## Access Compliance Report Public Rights-of-Way (Curb Ramps)

Intersection ID: 43512 Main Street: BLUEBERRY\_HOLLOW\_PL Cross Street: VICTORIA\_BROOK\_LN Location: S

ADA ID: 01E00DF95350 Ramp Type: Perp Initial Pass/Fail: Fail Overall Compliance: No Severity Score: 13.75

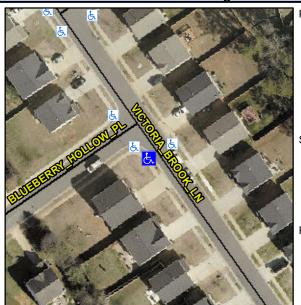
Not Found, R304.2.2

Possible Solutions:

Remove & Replace Entire Ramp.
